The Town of Niagara-On-The-Lake

Report: MHC-21-007 **Committee Date: March 09, 2021**

Report To: Municipal Heritage Committee
Subject: 135 Queen Street
Fulfilment of Conditions for Heritage Permit H-18-023

6 PLAZA FOUNTAIN DETAILS

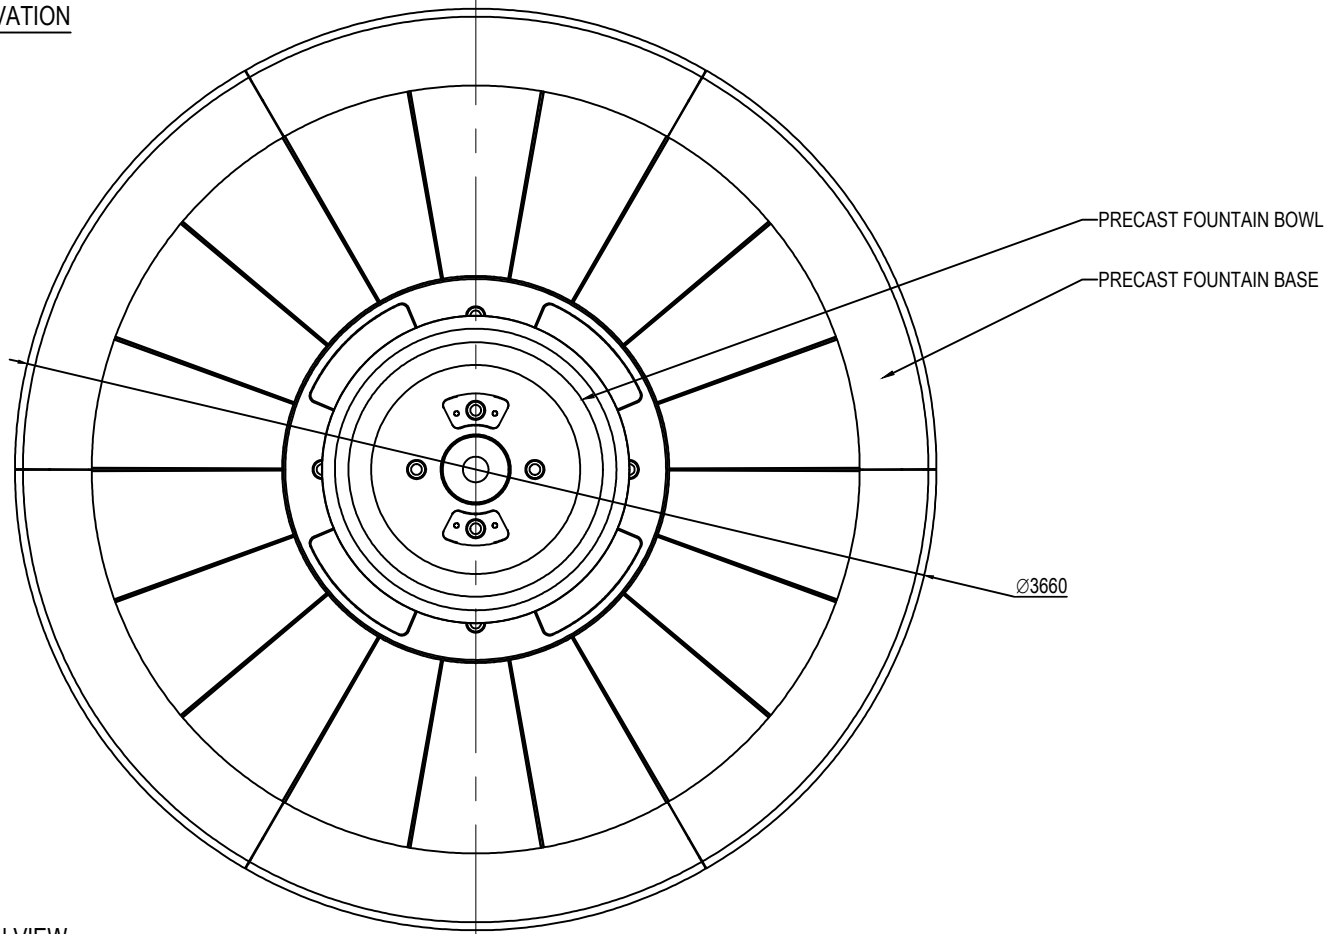
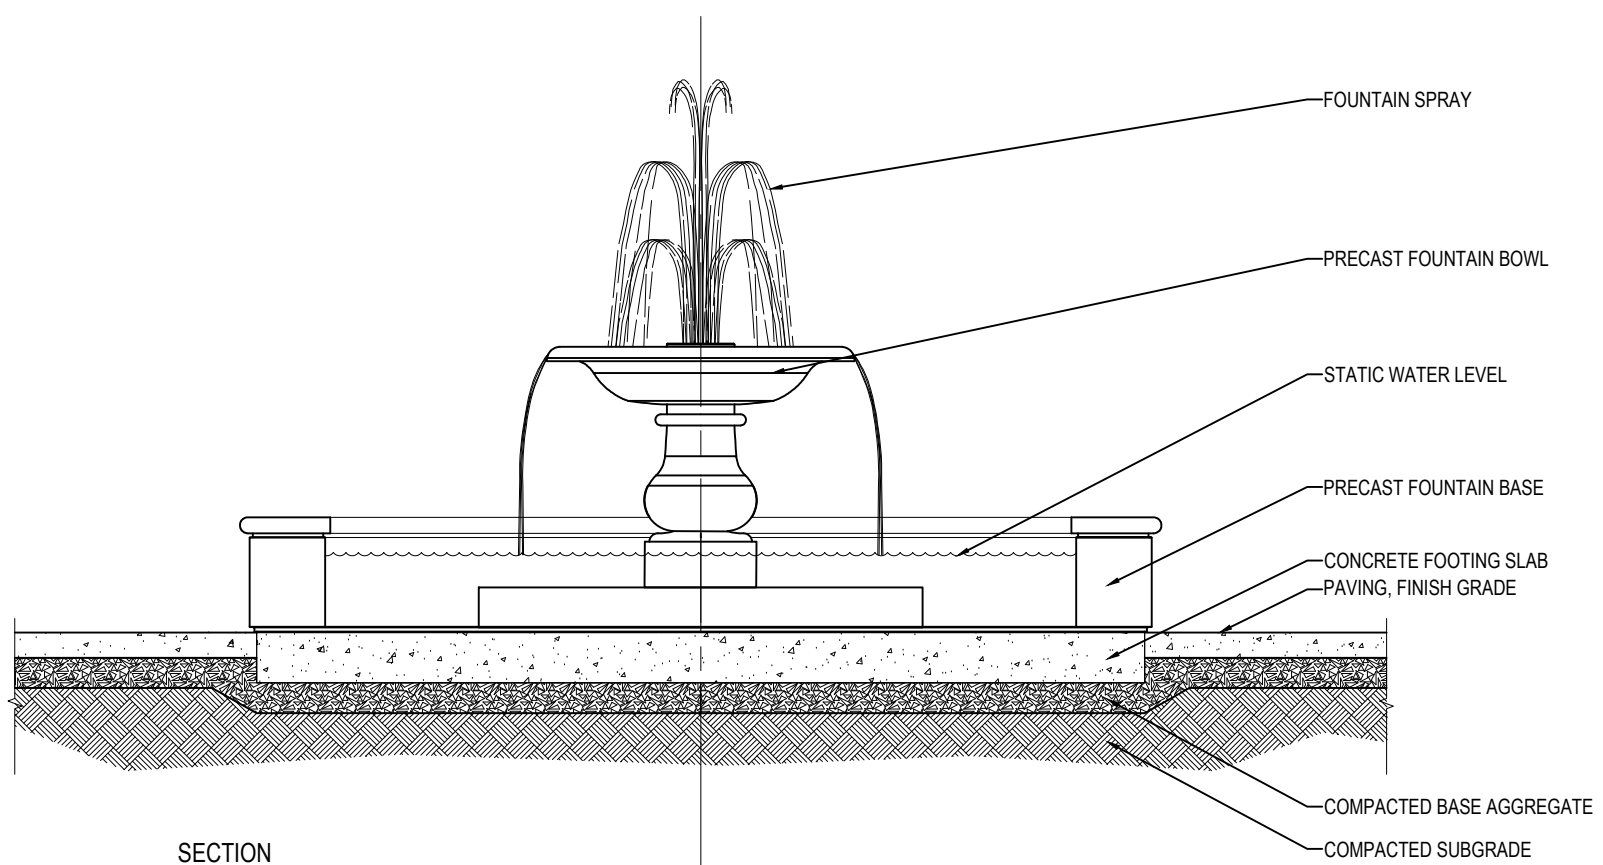
1.1 Condition #3 of Heritage Permit H-18-023 for 135 Queen Street, pertaining to final approval of the water fountain, be considered satisfied by the Municipal Heritage Committee, and the water fountain be designed substantially in accordance with the designs submitted in **Appendix A**; and

1 SITE PLAN.
 1 : 200

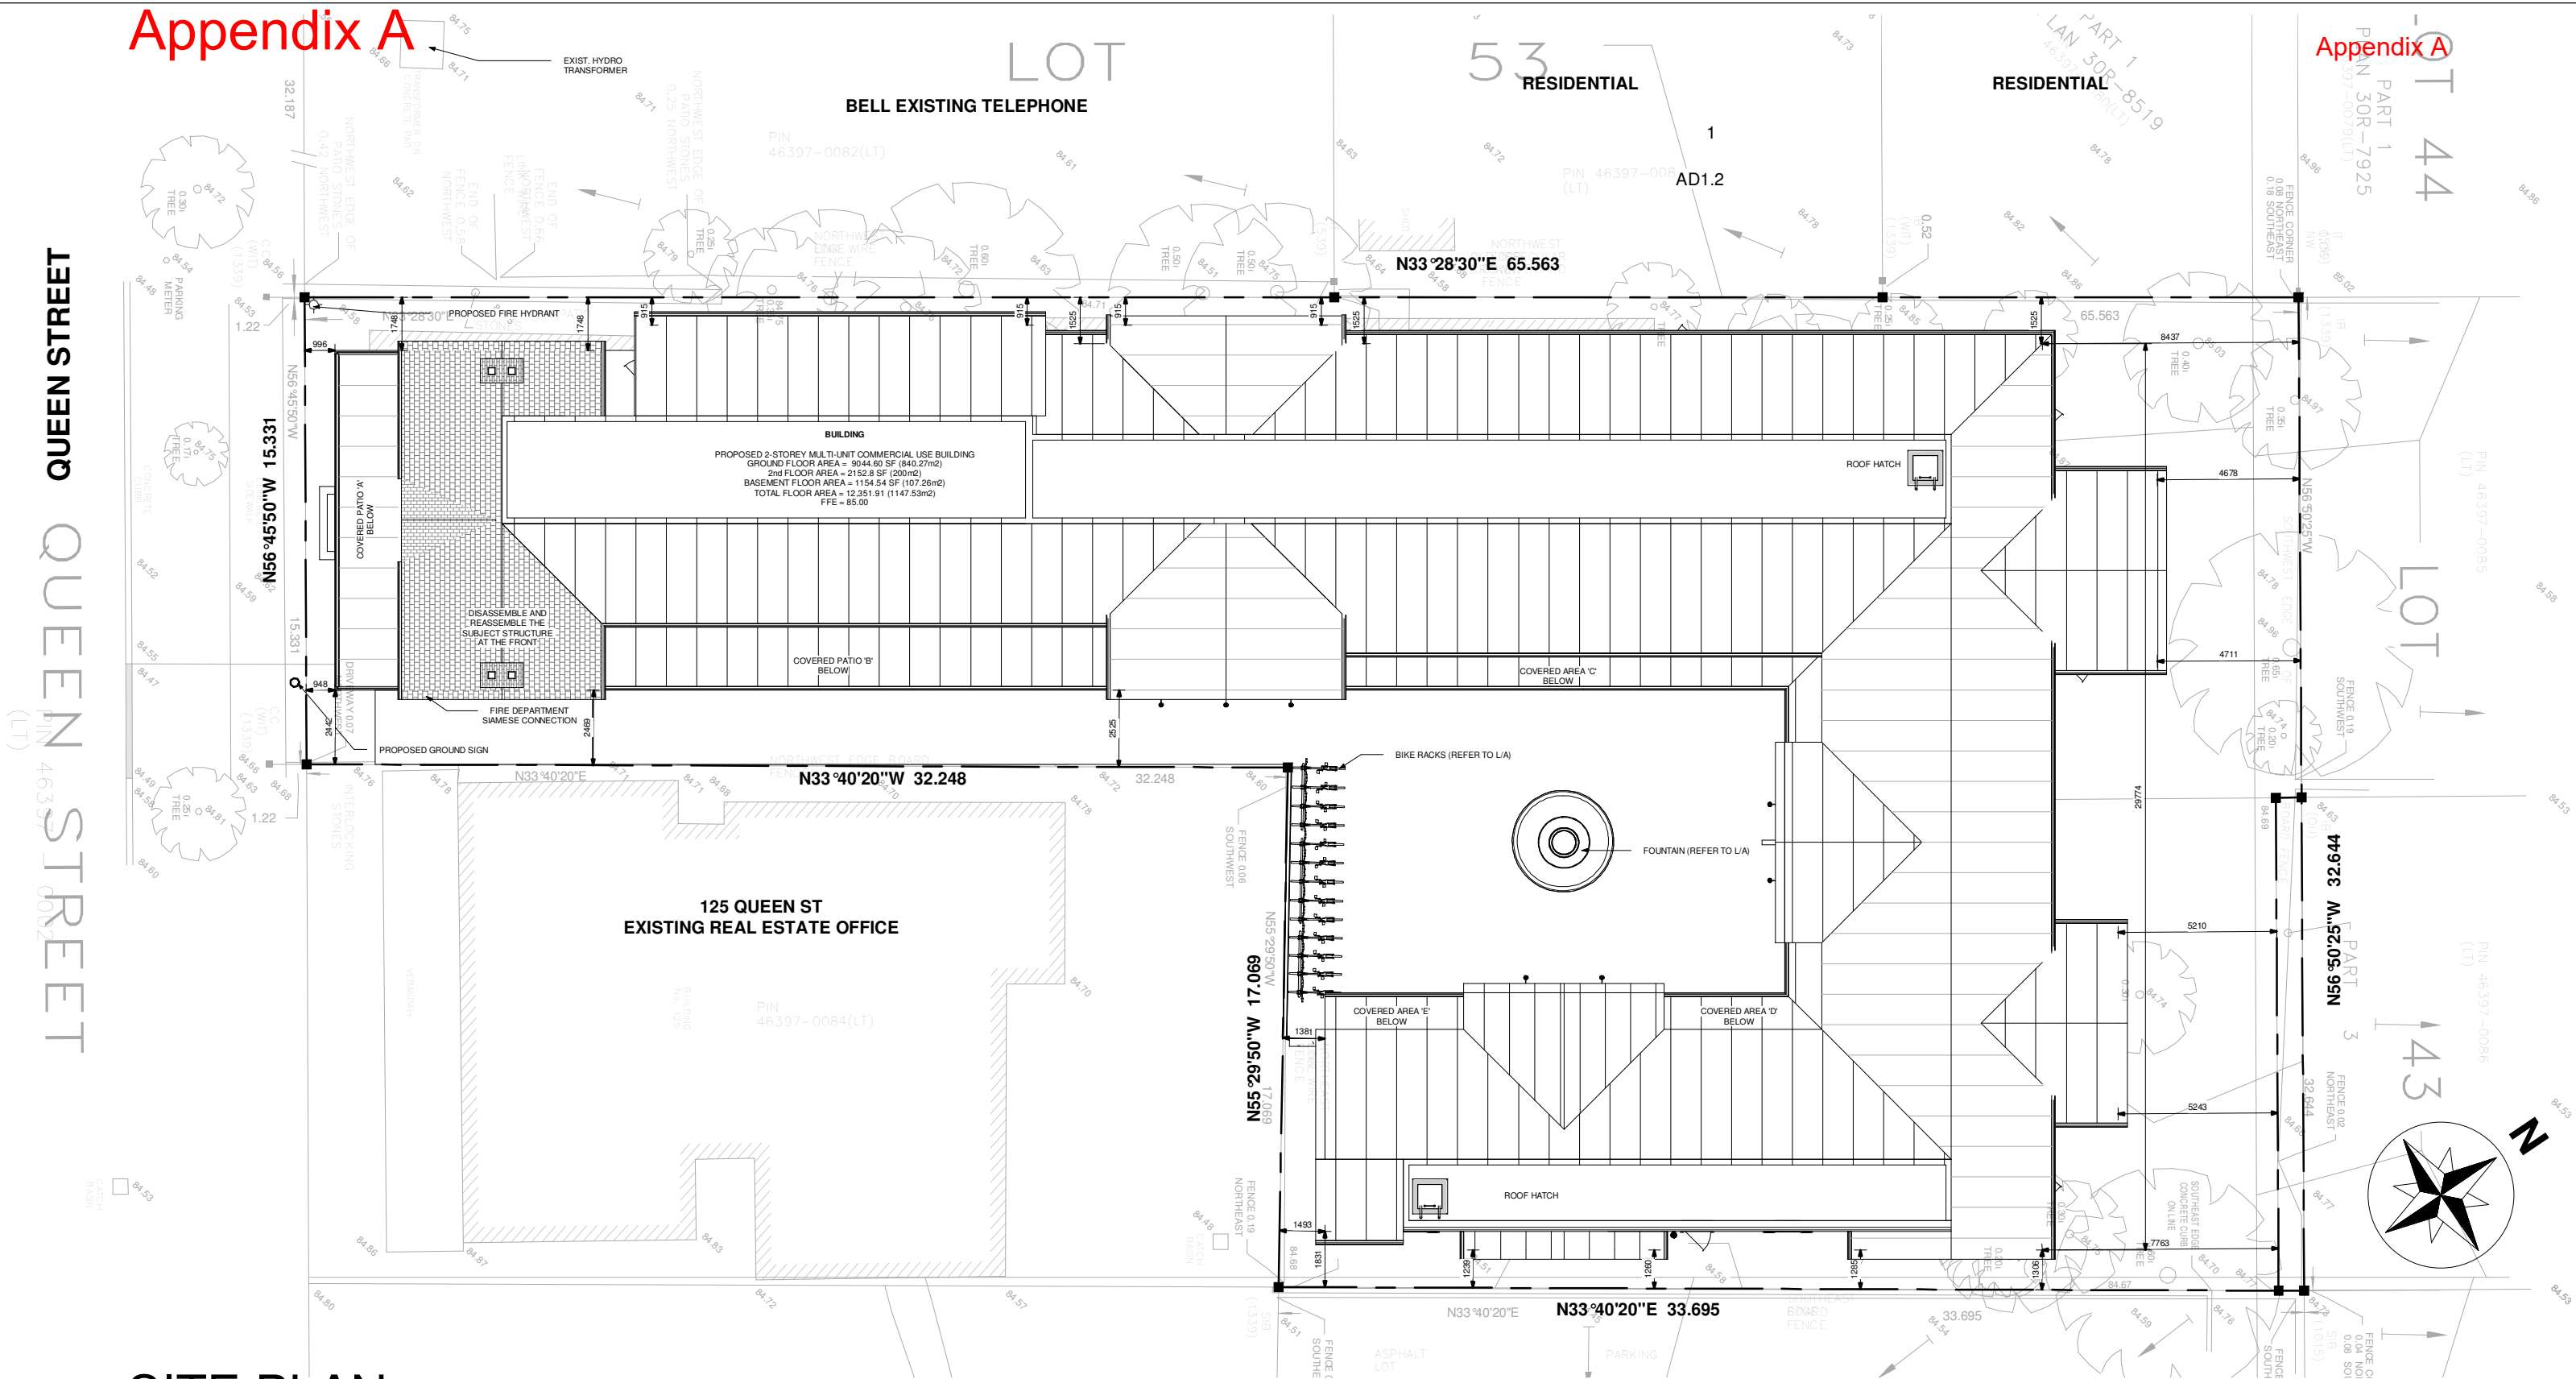
A Landscape Plan has been prepared, which includes the provision of interlocking pavers and a fountain in the middle of the site. A cedar hedge is proposed at the rear of the site to mitigate impacts on the abutting rear residential use. Planting beds are included throughout the site consisting of ground-covers, shrubs and perennials. In general, the proposed landscaping appears to provide for a functional and useable amenity space for the commercial property.

Staff note that there are a lack of trees planted internal to the site. Section 6A.3.3 of the District Plan encourages tree planing within the business area of the District. While the overall landscaping plan is well-designed, it is recommended that the applicant explore options to incorporate the planting of trees internal to the site, without adversely impacting the archaeological resources on the property. Details of the water feature have not been provided at this time, and it is requested that the water feature receive final approval by the Municipal Heritage Committee.
